# Land Use Policy Framework

Working Group Feedback – September 19, 2024

# River Park

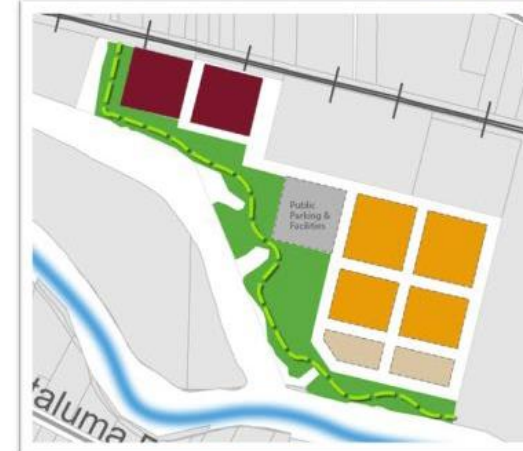
**WG Feedback:** Maximize equity access to the River with dense housing and some public parking. Modified Alt 2: Downtown Mixed Use / MU2 (4 stories), Urban Corridor Mixed Use / T5.5 (5 stories). Intensify use with Oyster Cove as starting point., feathering up from Oyster Cove (from 3 stories to 4 stories) and up to 5 stories back from the River.

# Petaluma Blvd No

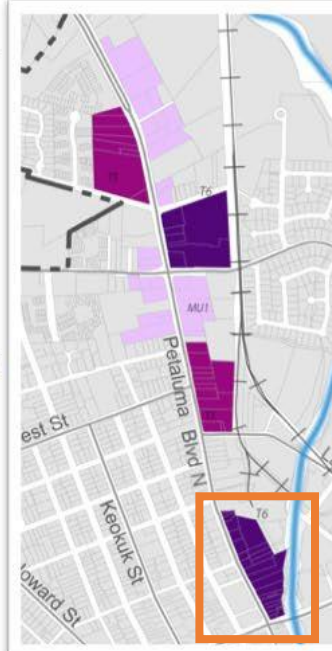
**WG Feedback:** Modified Alt 2, reduce the area abutting Washington to Urban Corridor Mixed Use / T5.5 to minimize sight line disruptions to the River.

# East Washington

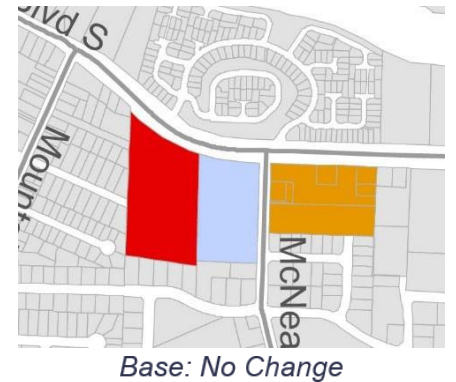
**WG Feedback:** Alt 2, intensification feeds trains and enhanced transit hubs, but intensity may need to be bumped up as we approach the freeway (not pictured here, see notes).

# Potential 15-Minute Activity Center: Western & Baker

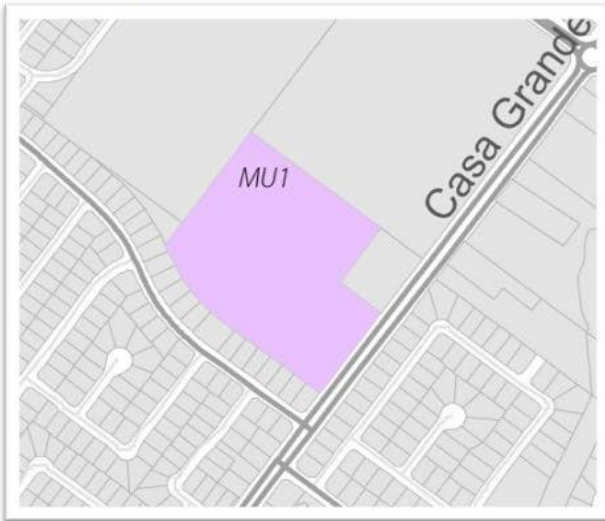
**WG Feedback:** Alt 2, with Creamery as “height hub”, turn this area into a thriving activity center.

# Potential 15-Minute Activity Center: Casa Grande Center

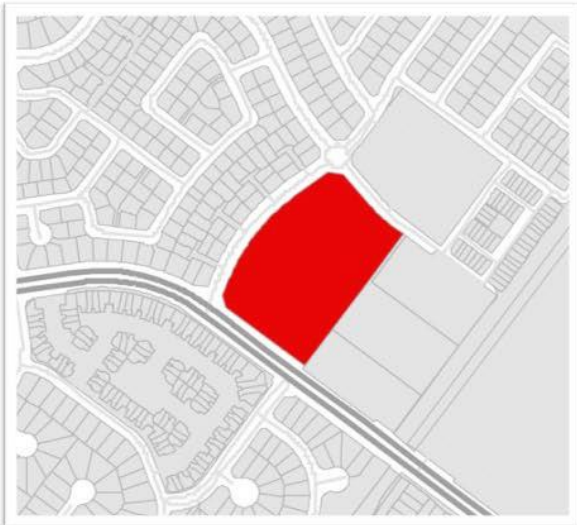
**WG Feedback:** Modified Alt 3, replace the Medium Density Residential (up to 3 stories) with High Density Residential (up to 4 stories).

# Potential 15-Minute Activity Center: Leghorn Marketplace

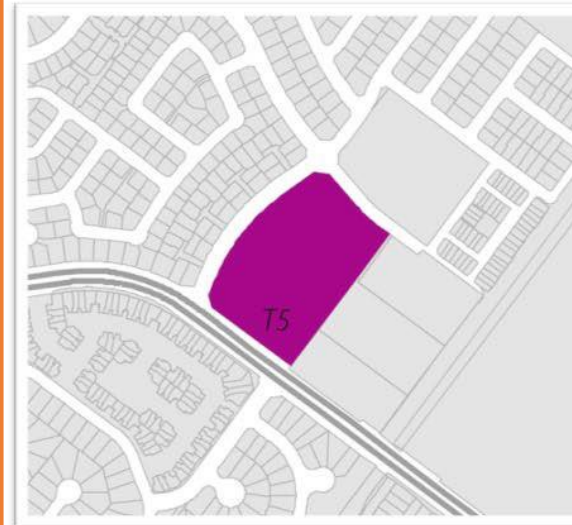
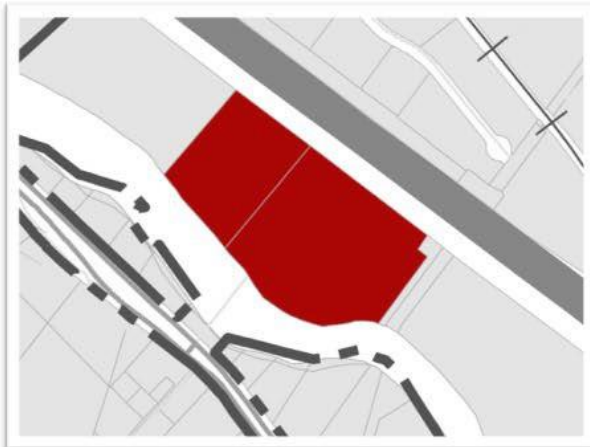
**WG Feedback:** Support intensifying to 4 story, Urban Center Mixed Use / T5 to support small workforce housing and bring in the density needed to support businesses in the area.

# Potential 15-Minute Activity Center: The Outlets

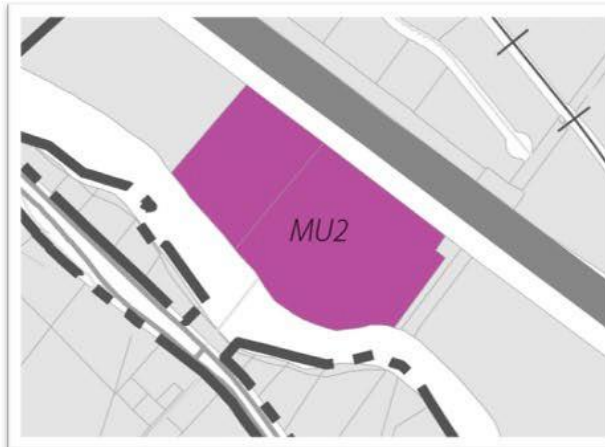
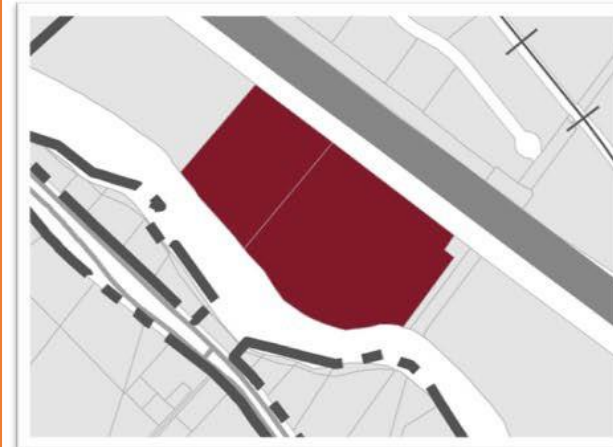
**WG Feedback:** Support Alt 2 because of flooding in this area. We don't support residential uses, we don't want residents to be cut off when the parking lot is inundated (for example).
